DATE ~~R~~ Sep.15/01**V2500-A1 PROPULSION SYSTEMS SERVICE BULLETIN**

This document transmits Revision 2 to Service Bulletin EV2500-72-0051

**V2500-ENG-72-0051**  
 Transmittal - Page 1 of 2

ENGINE – LP COMPRESSOR – INCORPORATE A FUEL DRAIN TUBE IN THE FAN FRAME ASSEMBLY

Location of the Fan Frame Assembly  
Figure 1

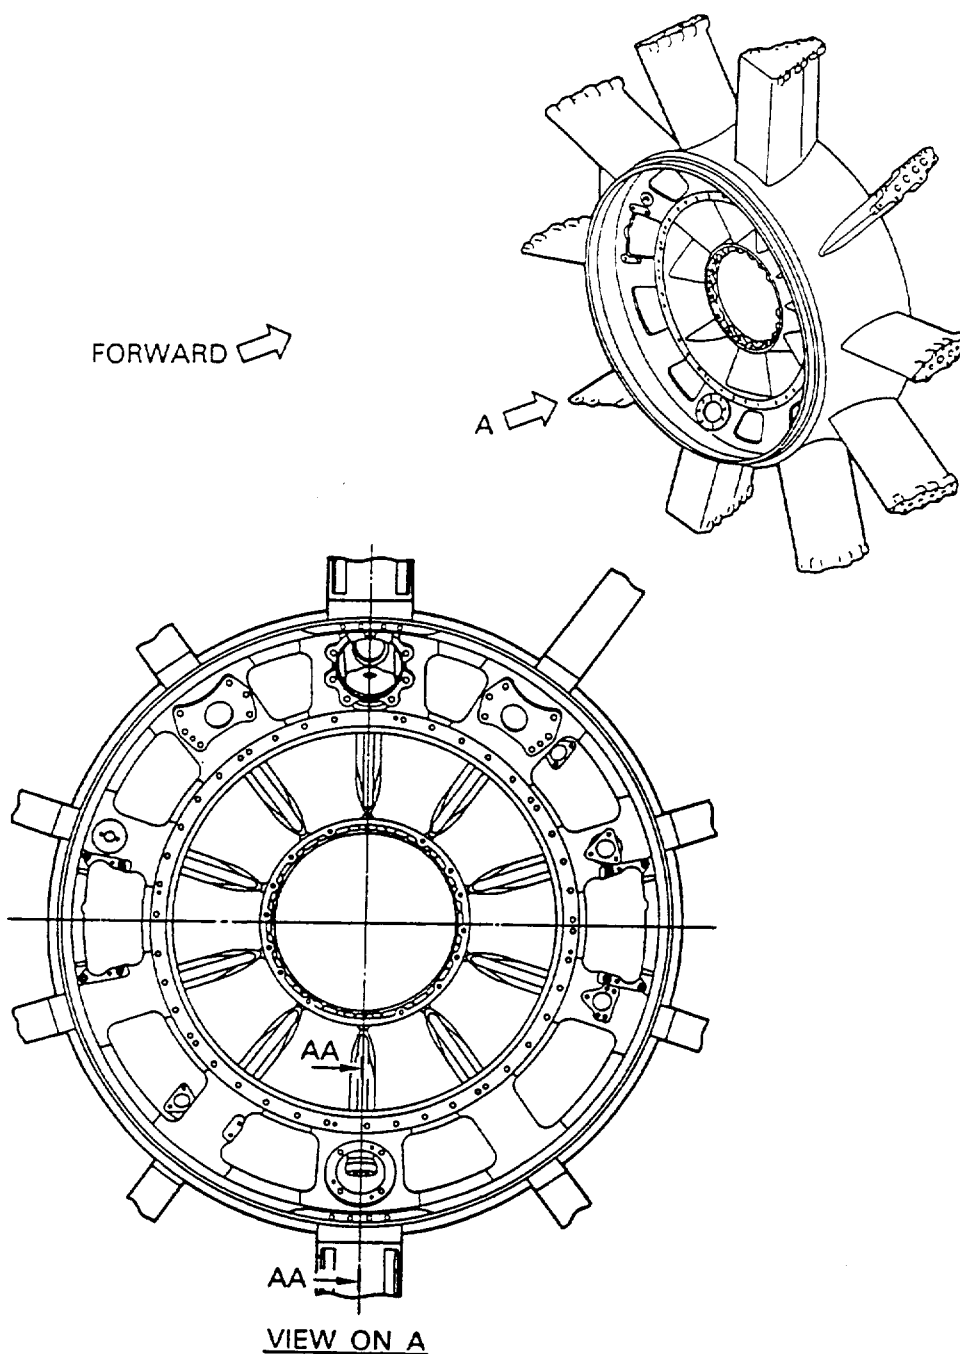
- (a) The existing filler compound which is included in the Fan Frame rear inner flange area has been removed. (See Fig. 1 and 2).
- (b) An additional drain tube is installed to the Fan Frame rear inner flange bottom through the additional hole in No. 6 Strut Fairing Panel A/O to drain out the fluid in the rear inner flange area. (See Fig. 1 and 2).

Fan Frame Assembly - Before and after alteration  
Figure 2 (Sheet 1 of 2)

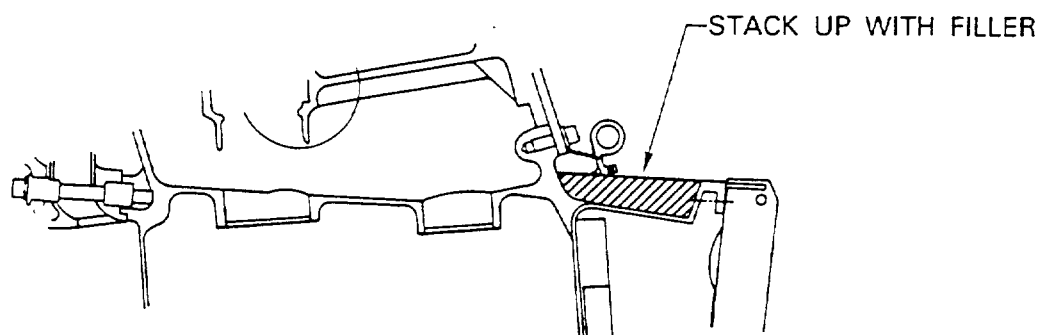
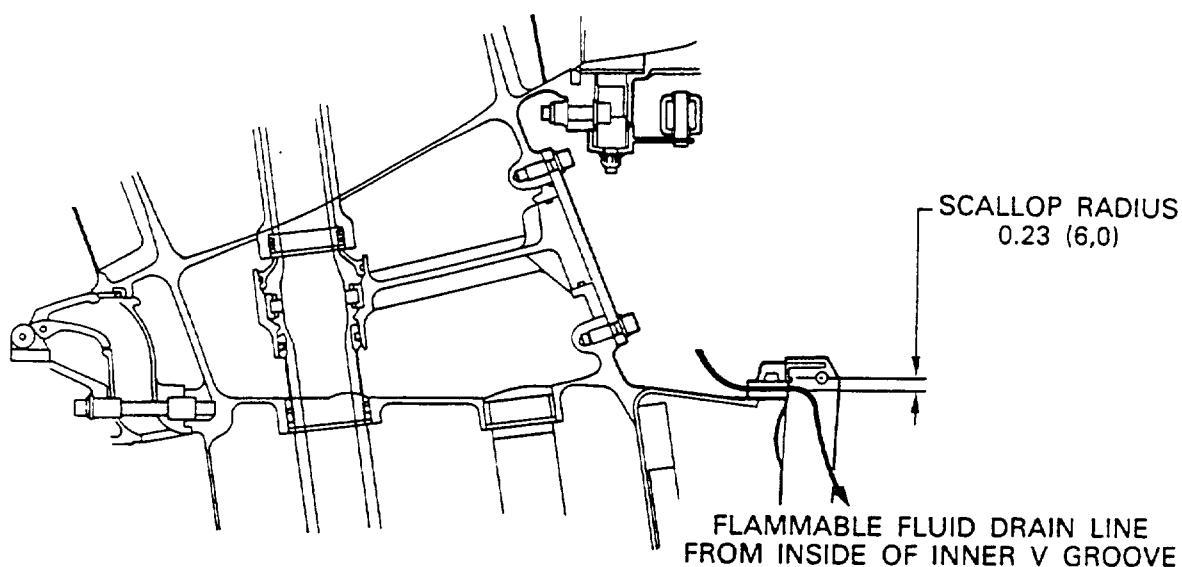
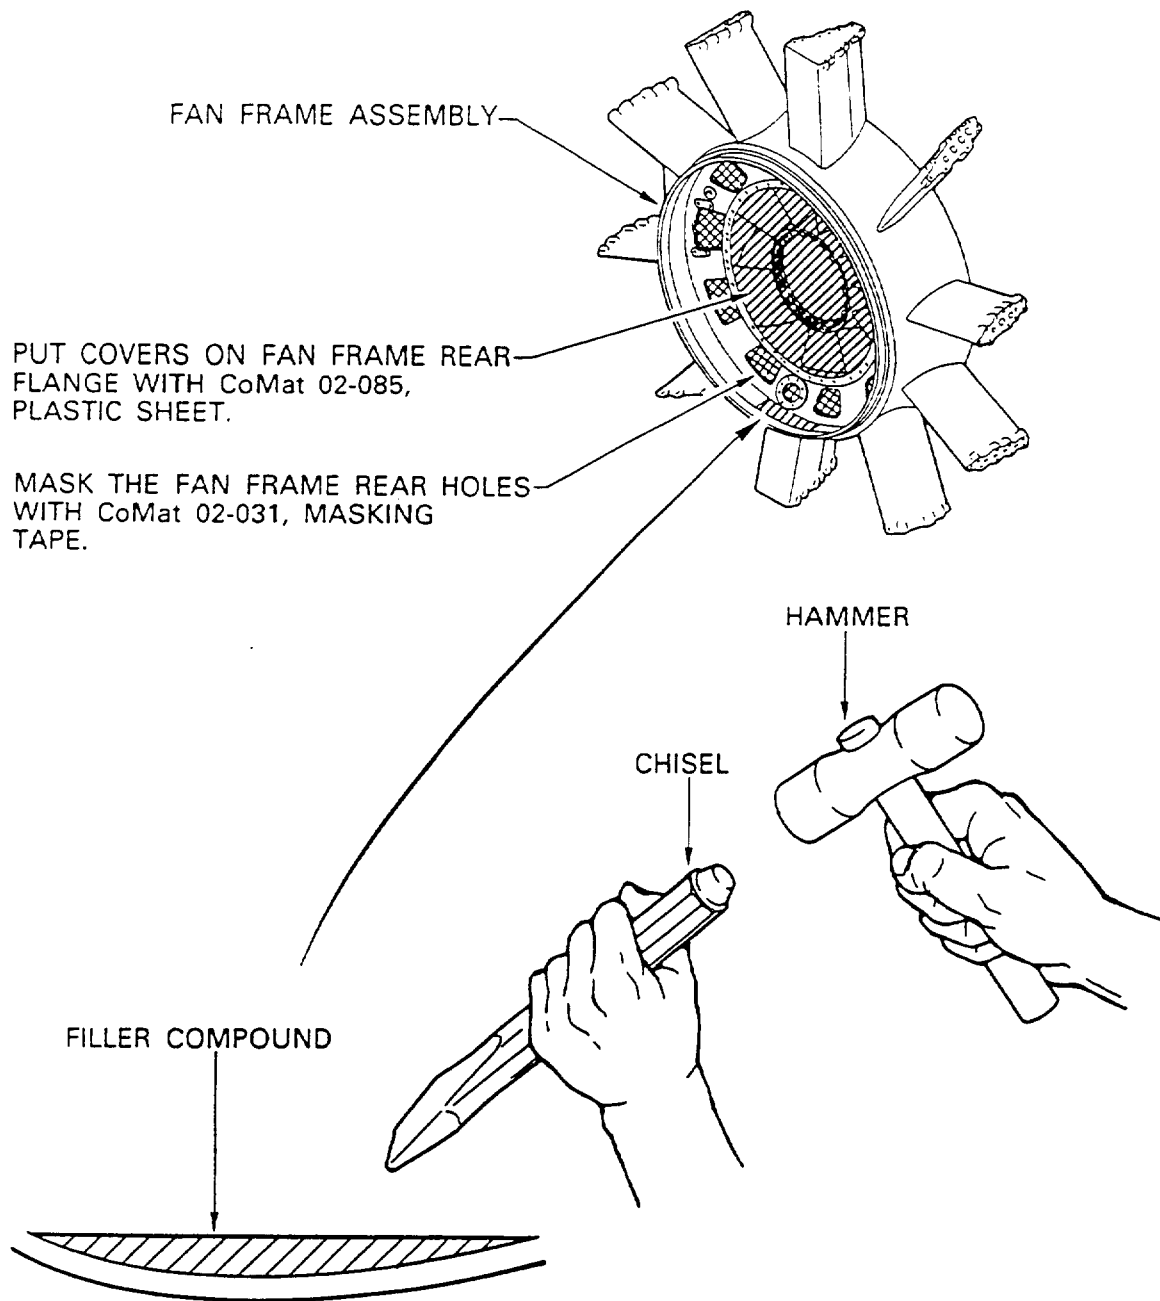
SECTION AA - AA, - BEFORE ALTERATION

SECTION AA - AA, - AFTER ALTERATION

Rework of the Fan Frame Assembly - Remove the filler compound  
Figure 3

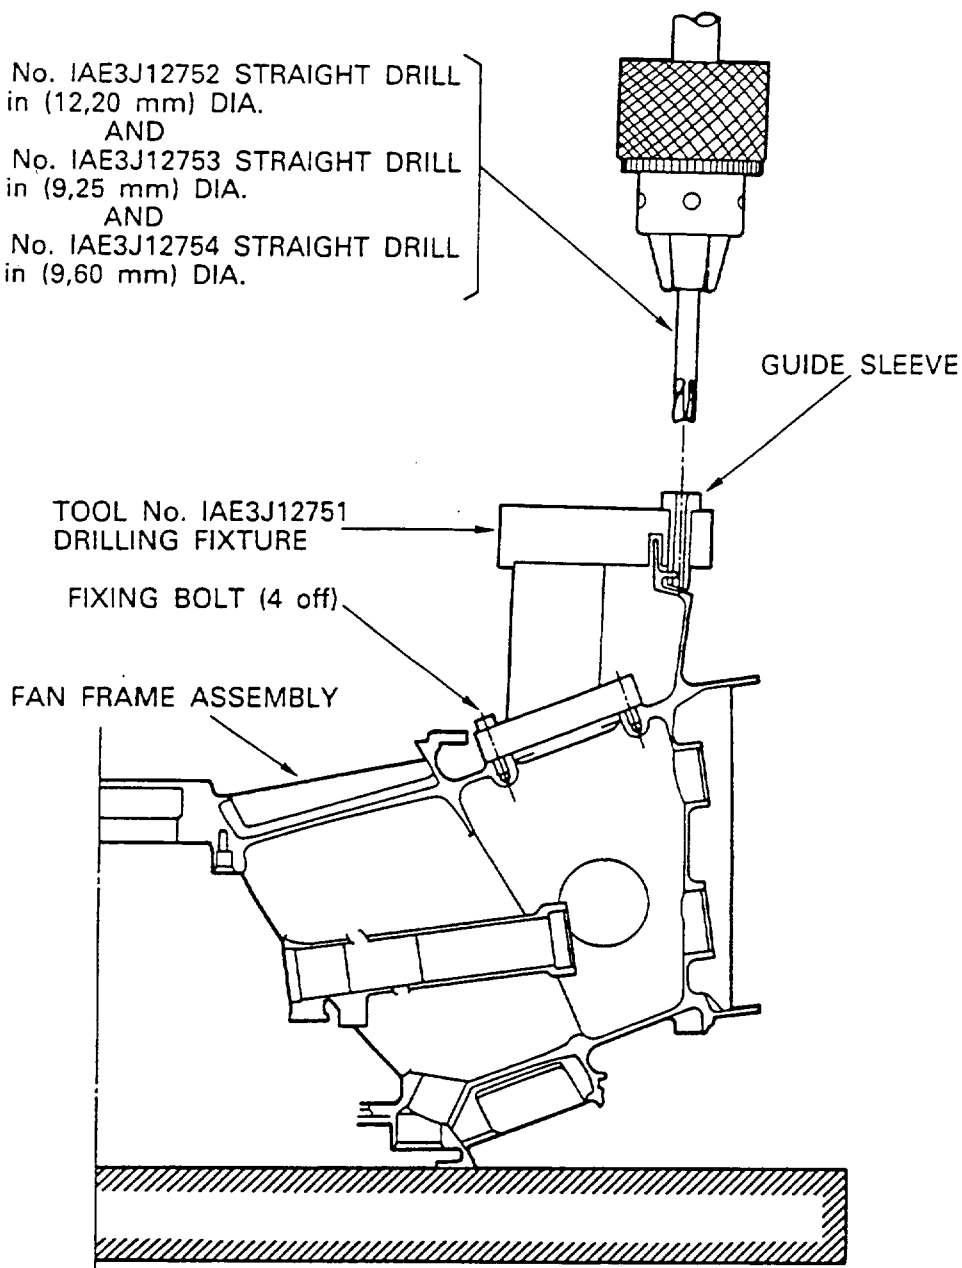
| (3) Remove the filler compound which is included in the Fan Frame rear inner flange area with the Chisel and the Hammer in the Mechanic's Tool Box. | Refer to Figure 3, and 1.K.(6)                  |

Rework of the Fan Frame Assembly - Drill the Drain Tube Hole and Scallop  
Figure 4 (Sheet 1 of 2)

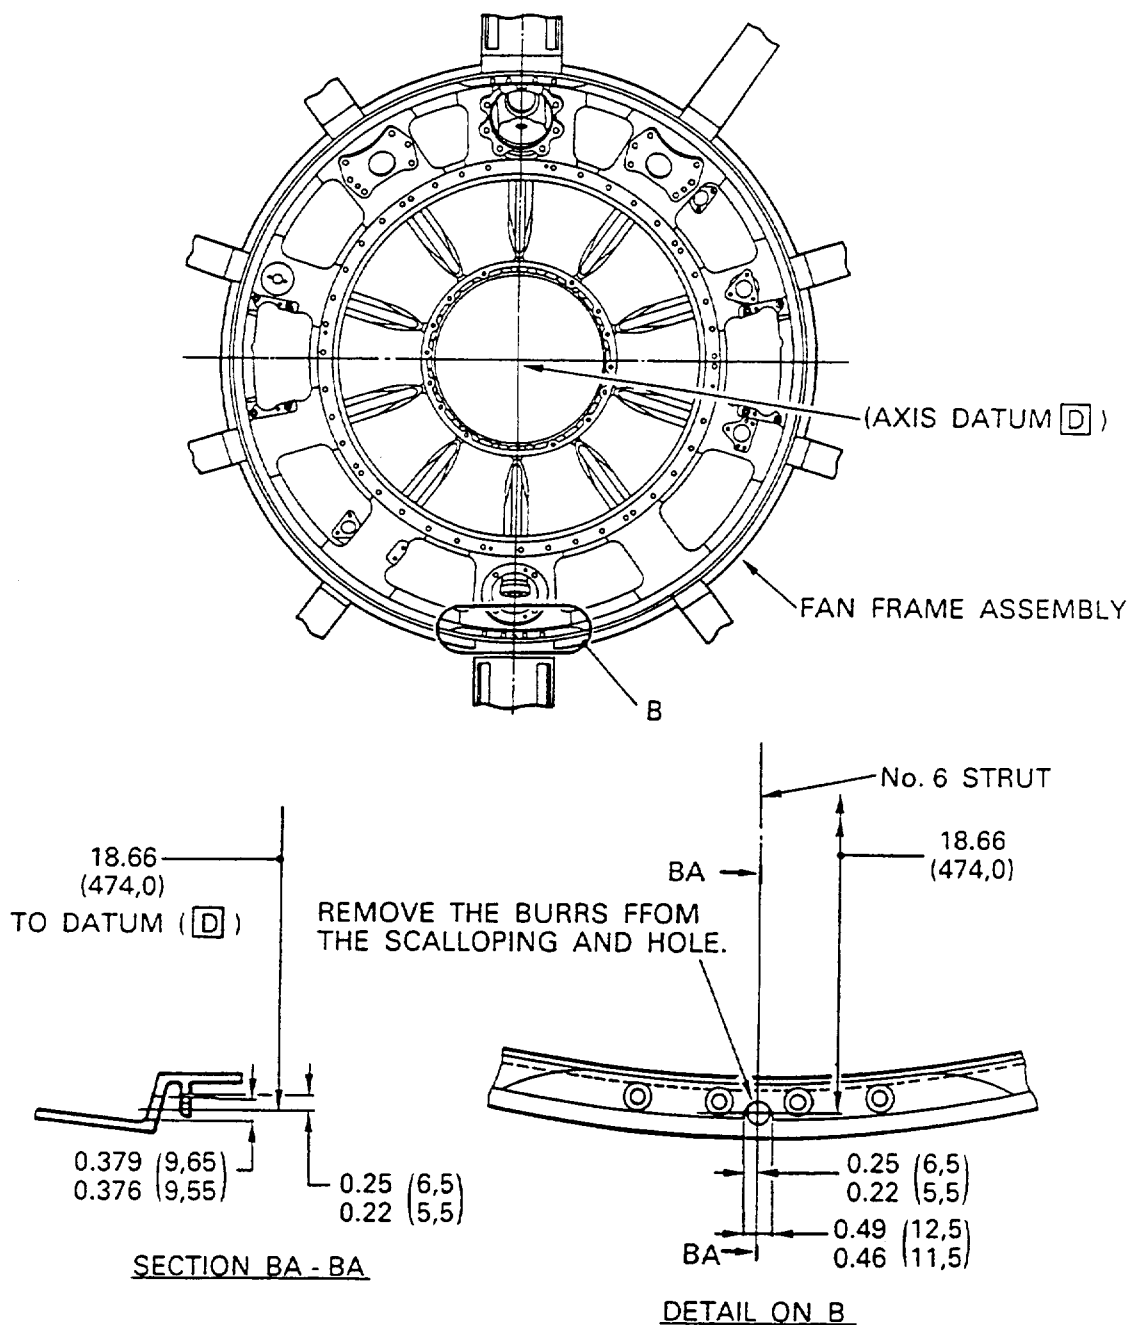
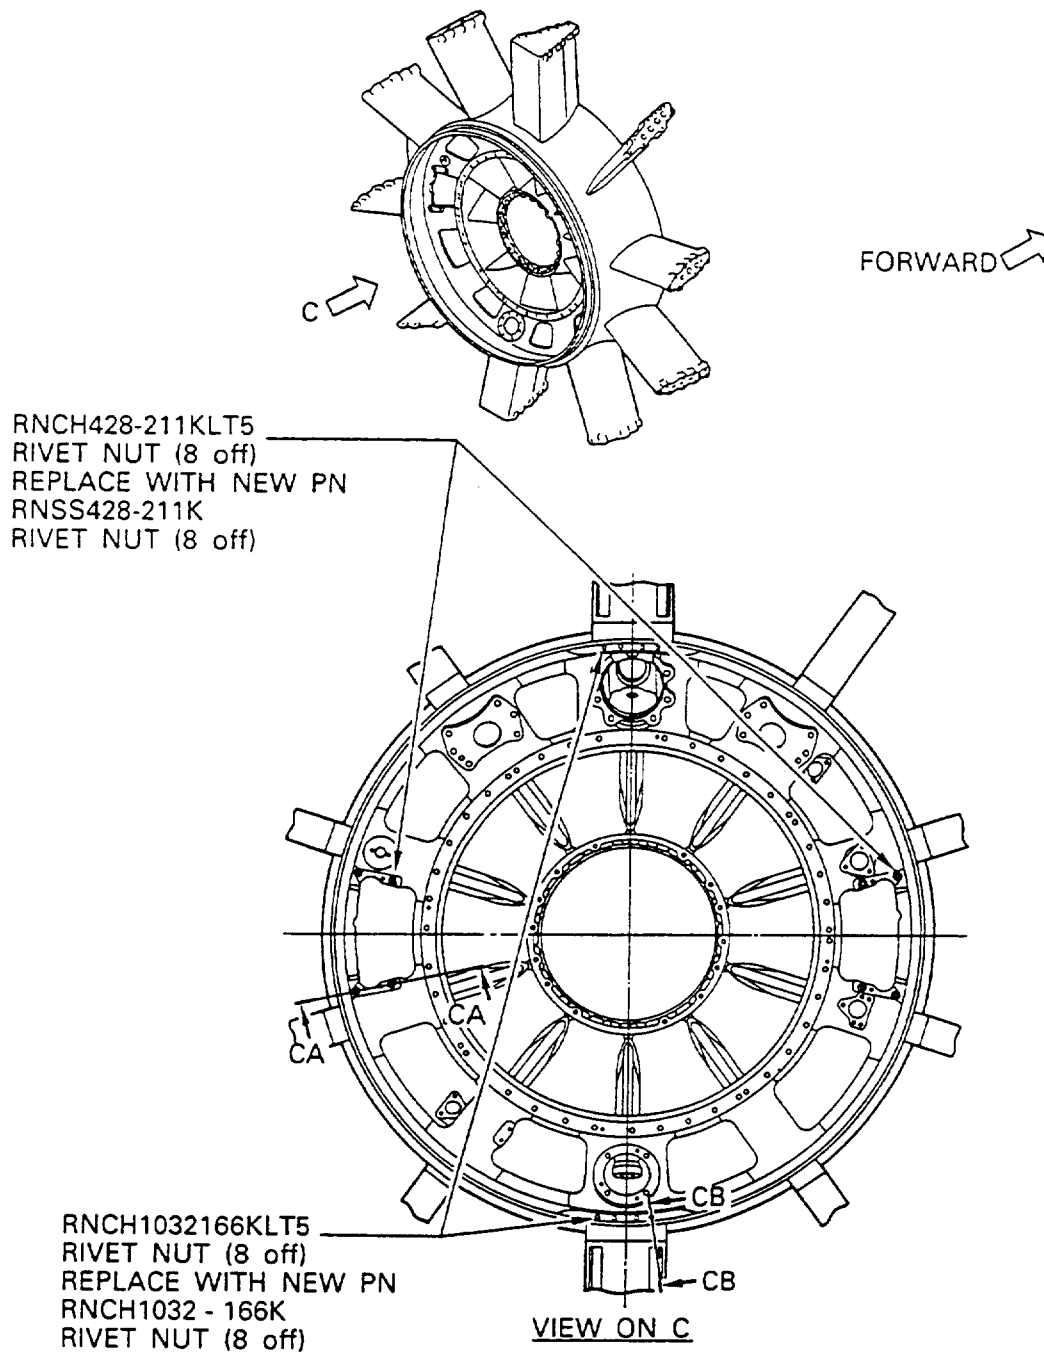
- (c) An additional hole is drilled on the existing No. 6 Strut Fairing Panel A/O as a drain tube path (See Fig 4).
- (d) The bolts and rivet nuts which secure the No. 1 and No. 6 Struts Fairing Panel A/O's and the BSBVA Brackets are replaced with the new bolts and rivet nuts to change a locking method from self lock to wire lock as follows:

| (4) Drill the drain tube hole and scallop on Fan Frame rear flange as follows:  | Refer to Figure 4, and 1.H. Tooling Information |

- (b) Set Tool No. IAE3J12751,  
Drilling Fixture, with the  
Guide Sleeve of 0.480in.  
(12,20 mm) inside diameter to  
the Fan Frame Assembly, and  
align three aligning holes in  
the Drilling Fixture with the  
locating pins of the Center  
Bearing Housing Assembly.

- (c) Safety the Drilling Fixture  
with four fixing bolts with a  
torque of 85 – 105 lbfin  
(10,00 – 12,00 Nm).
- (d) Set Tool No. IAE3J12752,  
Straight Drill 0.480in. (12,20  
mm) diameter, to  
Identification No. RM008,  
Boring Mill, and also set the  
Fan Frame Assembly with the  
Drilling Fixture to the Boring  
Mill  
Refer to 1.K.(7)

- (e) Make a scalloping on the Fan  
Frame inner flange by drilling  
through 0.480in. (12.20 mm)  
diameter hole of Guide Sleeve  
in the Tool No. IAE3J12751,  
Drilling Fixture

- (g) Drill 0.364in. (9,25 mm)  
diameter of a pilot hole on  
the Fan Frame inner Flange  
through the guide sleeve hole  
in Drilling Fixture

Rework of the Fan Frame Assembly - Replace the Rivet Nuts  
Figure 5 (Sheet 1 of 3)

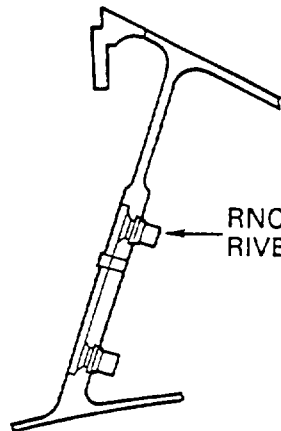
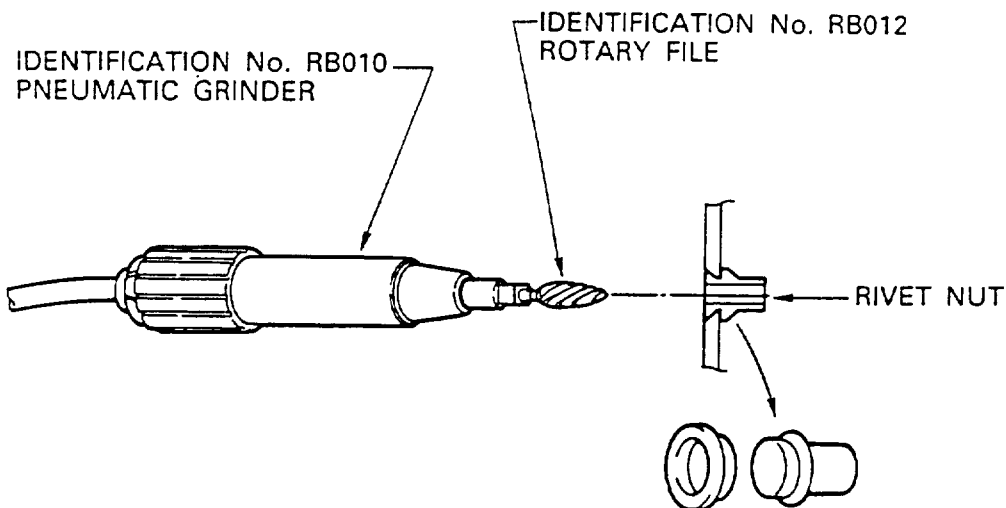
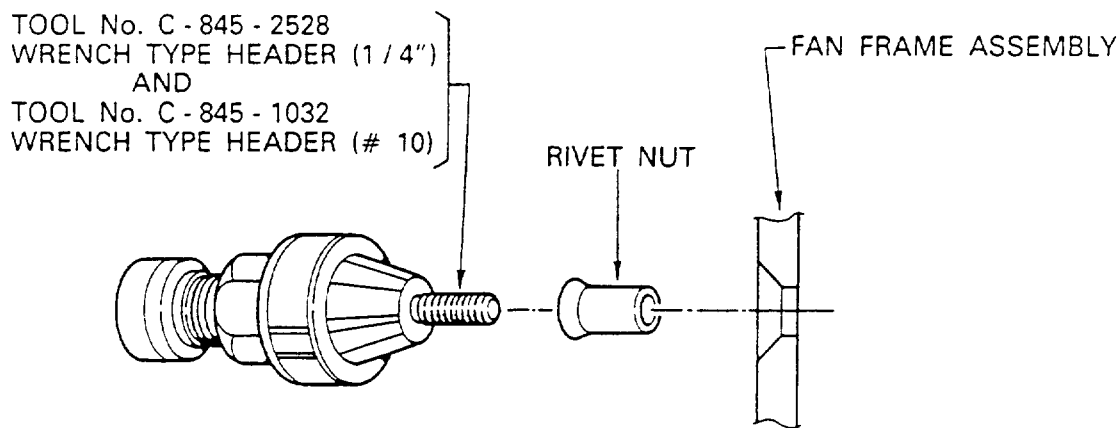
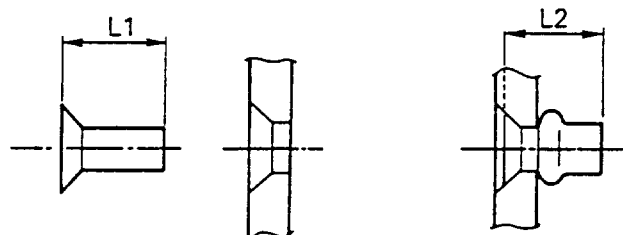
- (i) The existing eight RNCH428-211KLT5, Rivet Nuts, and eight RNCH1032166KLT5, Rivet Nuts, which are fitted on the Fan Frame Assembly are replaced with eight new RNSS428-211K, Rivet Nuts, and eight RNSS1032-166K, Rivet Nuts, respectively. (See Fig. 5).

- (5) Replace eight RNCH428-211KLT5, Rivet Nuts, to attach the BSBVA Brackets with eight new RNSS428-211K, Rivet Nuts, and also replace eight RNCH1032166KLT5, Rivet Nuts, to attach the No. 1 and No. 6 Struts Fairing Panel A/O's with eight new RNSS1032-166K, Rivet Nuts, as follows:
  - (a) Put CoMat 02-178, Masking Tape around each head of eight RNCH428-211KLT5, Rivet Nuts, and eight RNCH1032166KLT5, Rivet Nuts

REMOVE INSIDE MATERIAL OF RIVET NUT HEAD WITH  
IDENTIFICATION No. RB010, PNEUMATIC GRINDER,  
AND IDENTIFICATION No. RB012, ROTARY FILE  
TO CUT RIVET NUT.

FASTN THE RIVET NUTS ON FUN FRAME ASSEMBLY  
WITH WRENCH TYPE HEADERS.

EXAMINE THE LENGTH OF RIVET NUTS AFTER FASTENING  
ON FAN FRAME ASSEMBLY WITH IDENTIFICATION  
No..IT015 EXTERNAL MICROMETER

<u>RIVET NUT PN</u>	<u>LENGTH L1 (Ref)</u> <u>(BEFORE FASTENING)</u>	<u>LENGTH L2</u> <u>(AFTER FASTENING)</u>
RNSS428-211K	0.735 (18,67) 0.765 (19,43)	0.610 (15,50) 0.640 (16,25)
RNSS1032-166K	0.597 (15,17) 0.637 (16,17)	0.495 (12,58) 0.510 (12,97)
